Hallsville School District

All Purpose Field & Parking Lot
Primary School Classroom Addition
Secure Entry Doors

Progress Report #8

October 21st, 2026
BOE Meeting

SITE AND UTILITY PLAN

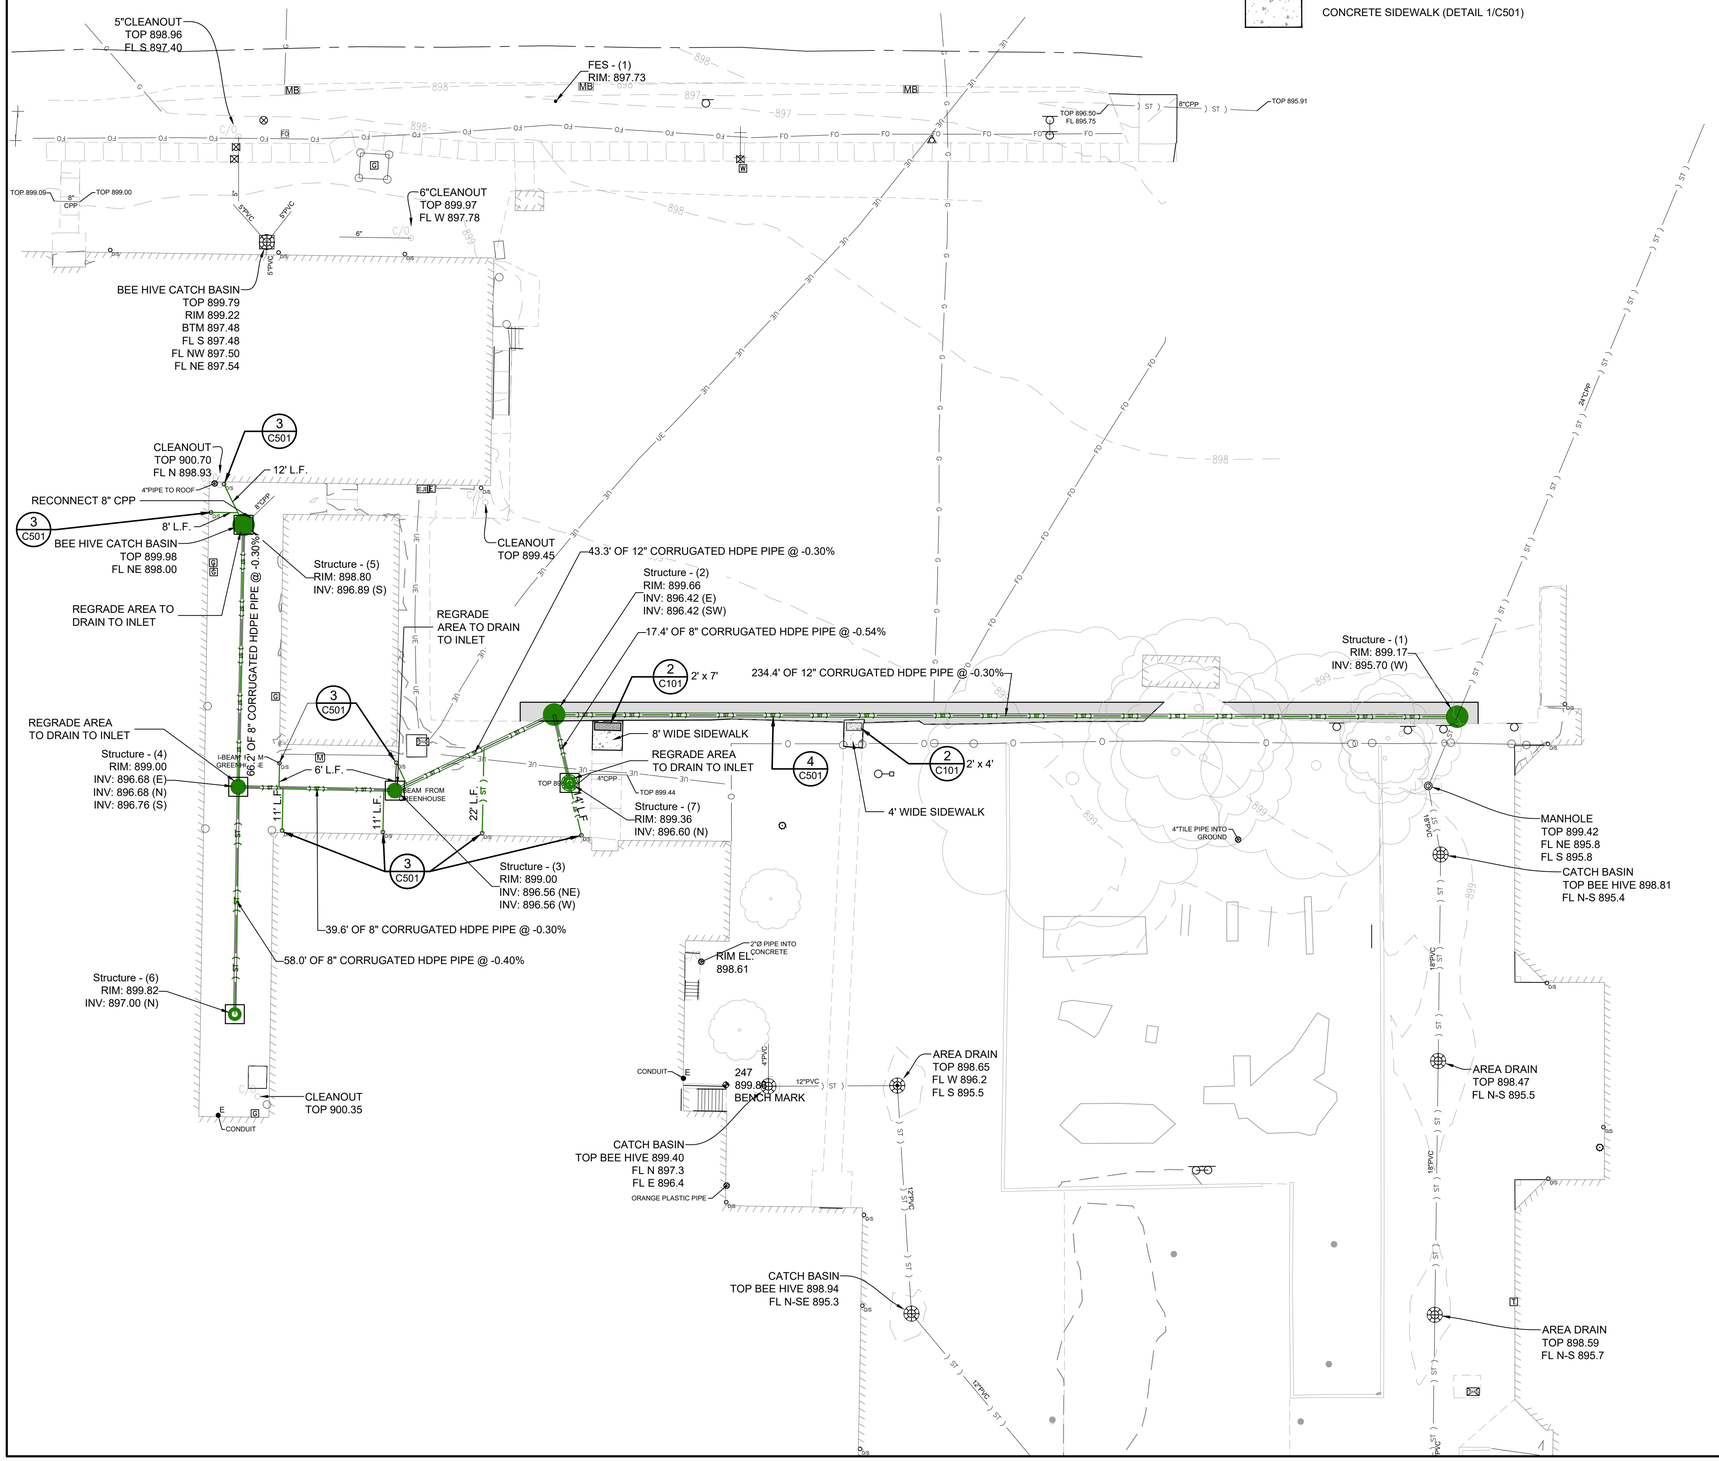
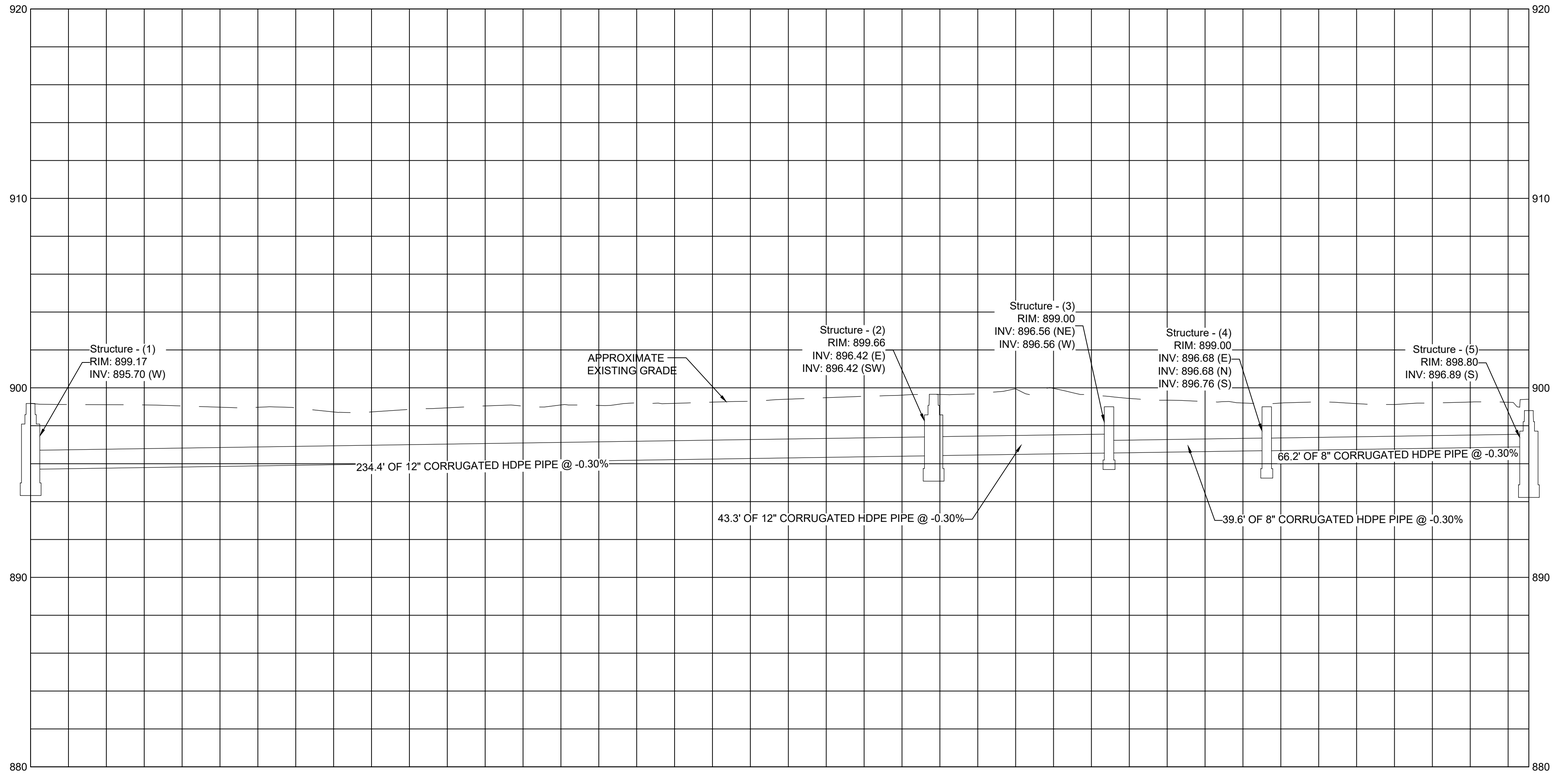
1	Plan set consisting of 8 sheets	Pavement removal and replacement to allow for storm sewer installation. Construction of new storm sewer west and south of the existing greenhouse and extension of new storm sewer to connect to the existing storm sewer to the east. Storm sewer includes inlets and downspout connects for both the greenhouse and school building.
